ELECTRONIC VALVE SPECIFICATIONS

SPECIFICATION CV1506 ISSUE 7 DATED 23.2.53

AMENDMENT No.1

VALVE ELECTRONIC CV1506

Page 3. Outline Drawing

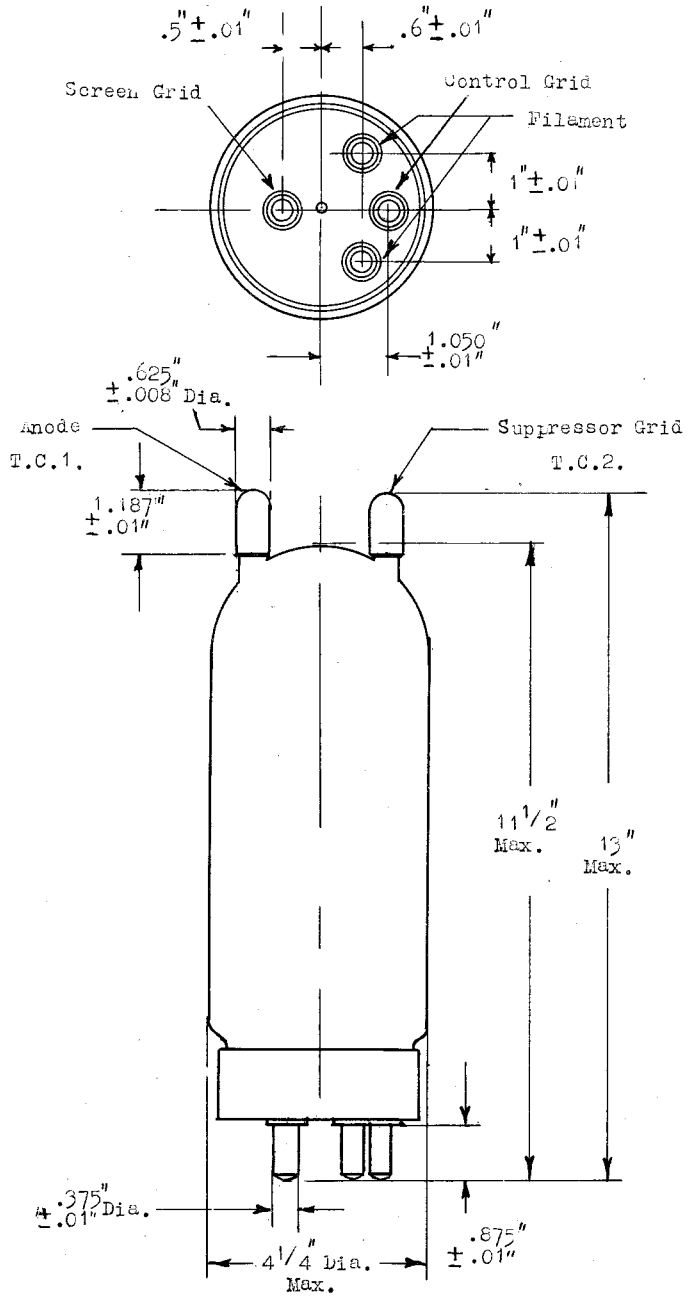
At foot of page insert the following note:

"NOTE. On finished valves allow an additional 0.1" for solder on both pins and top caps."
